Re: Russian School of Mathematics/200 Wells Avenue, Newton

I am writing this letter in response to the questions which you emailed to Alexandra Ananth following the July 11, 2013 public hearing on the above application to amend Board Order #325-06. In the interest of clarity, I will respond to the questions in the order in which they were posed.

TOPOGRAPHIC SITE PLAN  
 NEWTON, MASSACHUSETTS  
 SHEETING PREPARED CONFORMS AT  
 2500 WELLS AVENUE  
 PROJECT 2013  
 DATE MARCH 25, 2013  
 SCALE 1/8"=1'-0"  
 LAND SURVEYORS - CIVIL ENGINEERS, INC.  
 480 WASHINGTON STREET  
 NEWTON, MASSACHUSETTS  
 (617) 552-9911

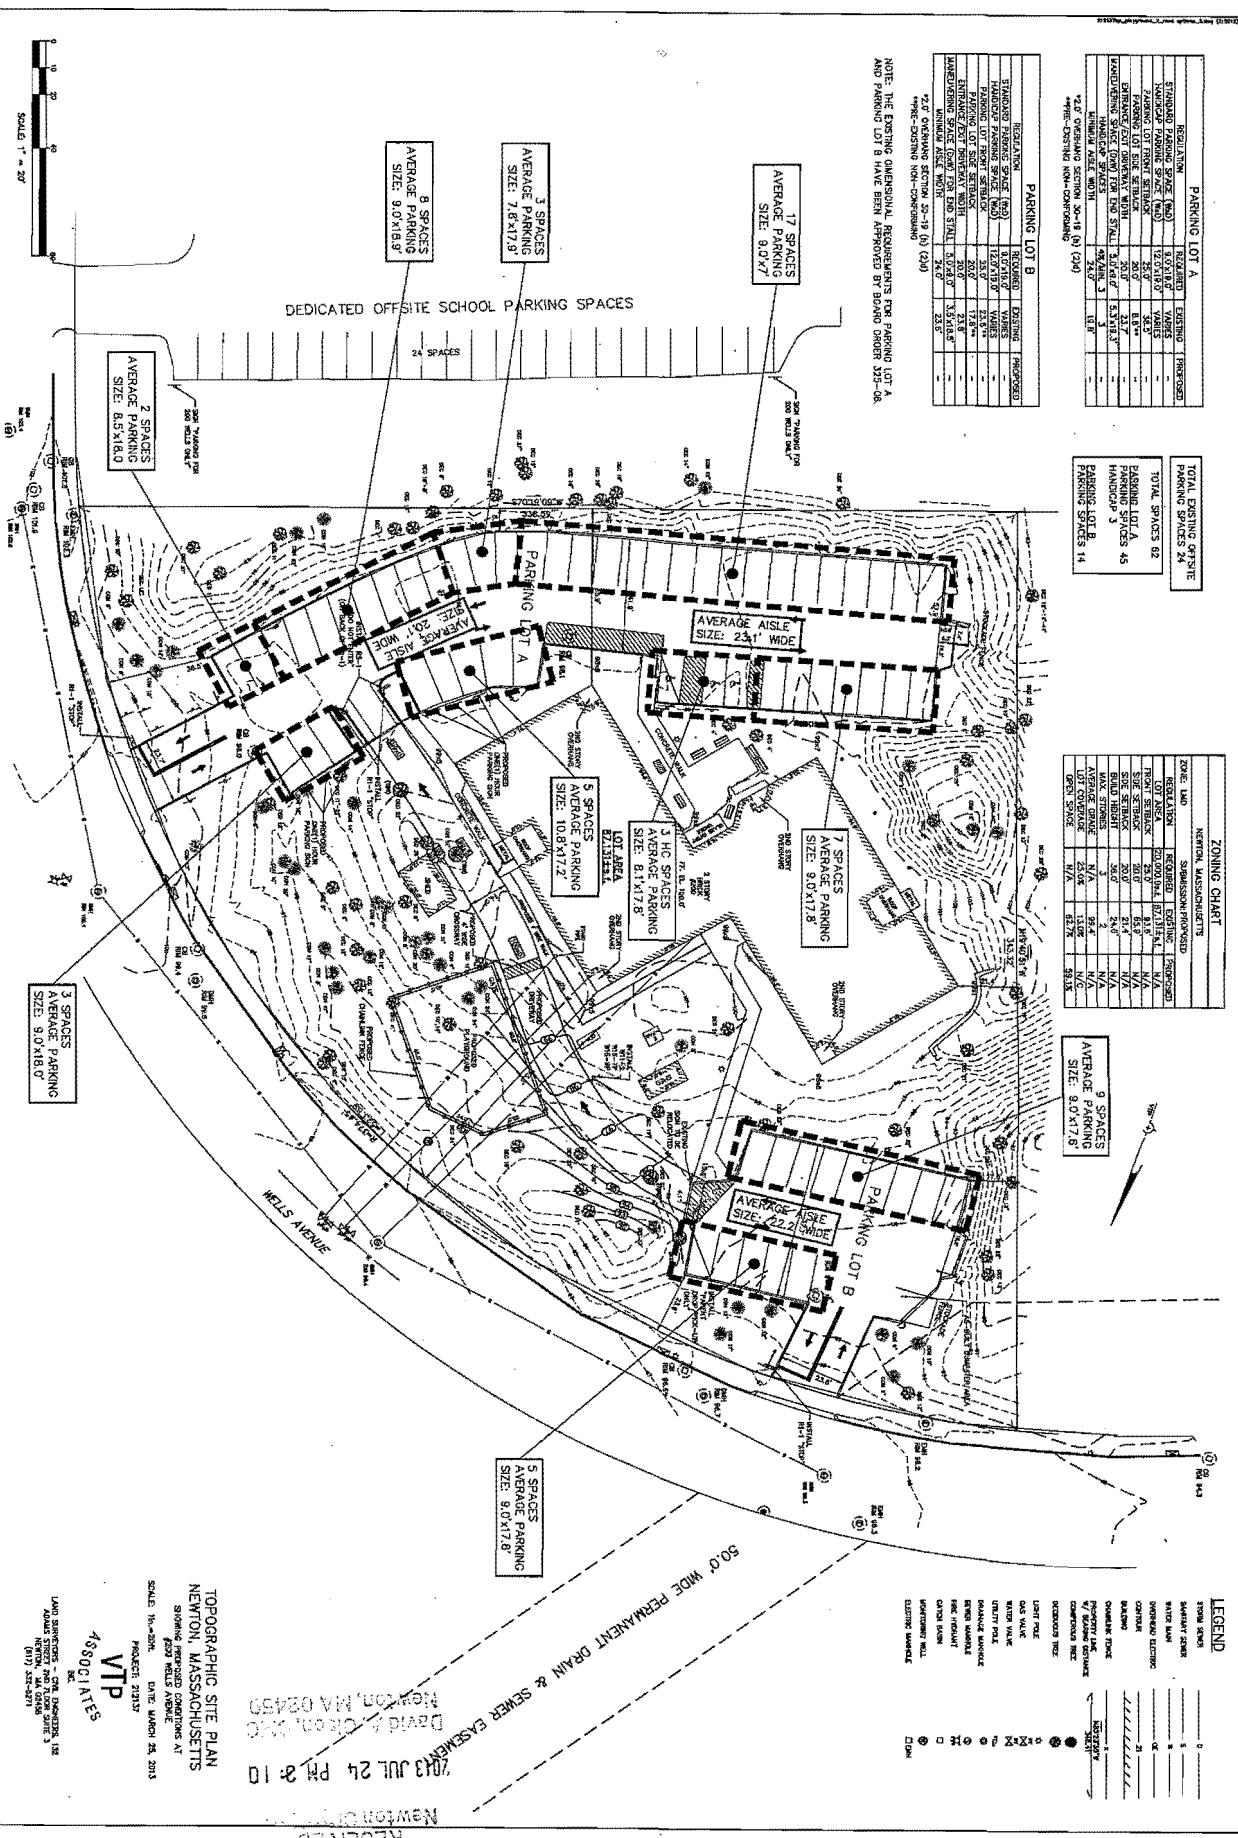
*The signage that's out there suggests 15 minute parking and the spaces and aisles appear undersized.*  
There is currently a 15 minute parking limit on Lot A, and a 5 minute limitation on Lot B. The limitations will remain in force. Staff will be directed to park in Lot B, and Lot A will continue to be 15 minute parking for pick-up of children.

Joe Porter, our site engineer, has measured the stalls and aisles and determined that most of the spaces are close to meeting the requirements of the Zoning Ordinances. A marked up site plan is enclosed for your reference. No space is less than 7.8 feet wide, and 54 of the 64 spaces are 9 feet wide or wider. Also, no space is less than 17.2 feet deep. The existing dimensional requirements for both lots were approved by Board Order #325-06.
